SUBJECT: ISSUANCE OF AMENDMENT NO. 4 TO AMENDED FACILITY OPERATING
LICENSE NO. R-130 - REGENTS OF THE UNIVERSITY OF CALIFORNIA
(TAC NO. 8391)

AMENDMENT TO AMENDED FACILITY OPERATING LICENSE

Amendment No. 4
License No. R-130

TECHNICAL SPECIFICATIONS
FOR THE
UNIVERSITY OF CALIFORNIA - DAVIS MCCLELLAN NUCLEAR RADIATION CENTER
(UCD/MNRC)

UCD/MNRC ORGANIZATION FOR LICENSING AND OPERATION
FIGURE 6.1

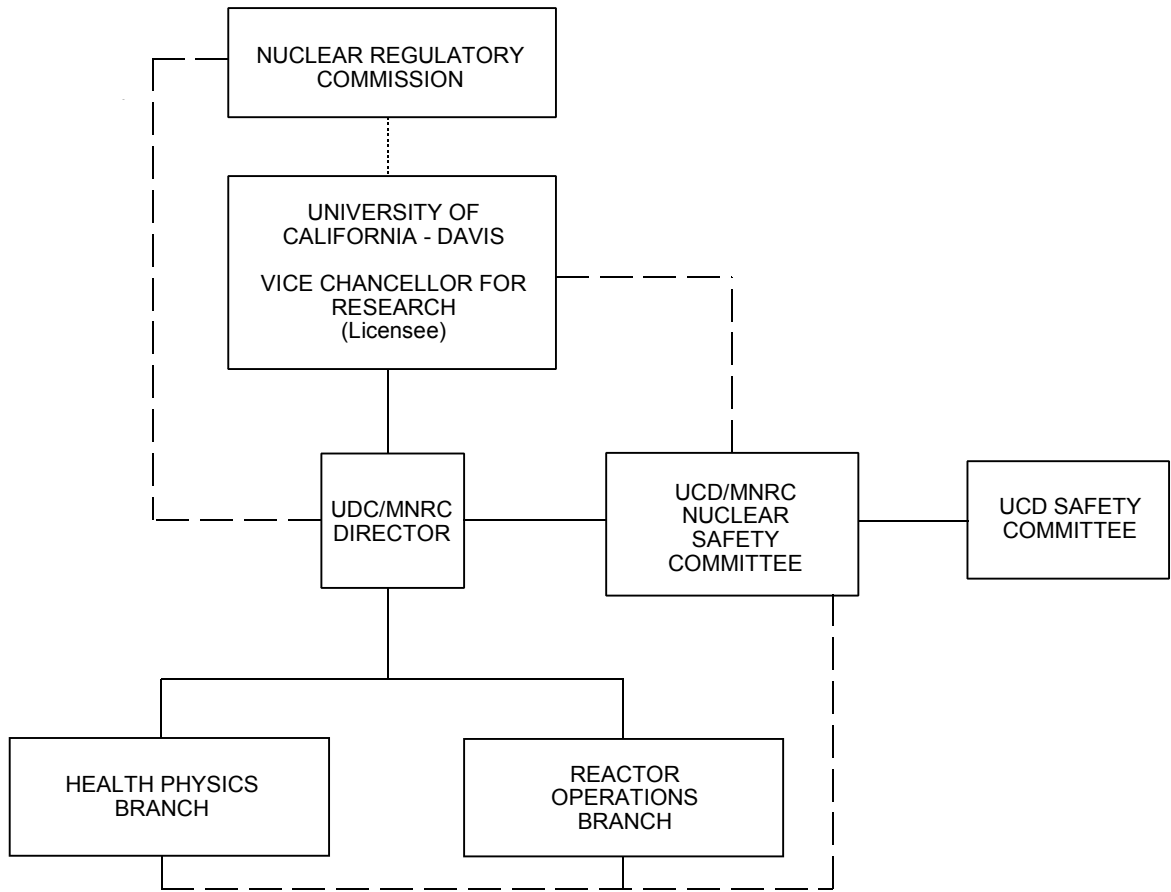
5. Section 5.3.1. A request to add the use of 30/20 TRIGA fuel and a new core fuel loading termed a 30B core.
6. Section 6.0. A request to revise the organization and duties of the Nuclear Safety Committee and to clarify the Committee's review and audit functions to reflect the new licensee.

6.1.1 Structure. The management for operation of the UCD/MNRC facility shall consist of the organizational structure as shown in Figure 6.1.

Section 6.0 of the Technical Specifications describes the administrative controls governing the operation and maintenance of the reactor and associated equipment. There are a number of minor changes with respect to titles and some changes with respect to the composition and duties of the Nuclear Safety Committee (NSC). The review and inspection functions of the NSC have been expanded to provide additional oversight. These expanded functions include review of the Emergency Plan and Physical Security Plan, review and update of the NSC Charter every two years, review of inspections conducted by other agencies, assessment of actions taken to correct deficiencies, inspection of currently active experiments, and inspection of future

plans for facility modifications or facility utilization. Since these changes increase oversight of facility operations, the staff concludes that they are acceptable.
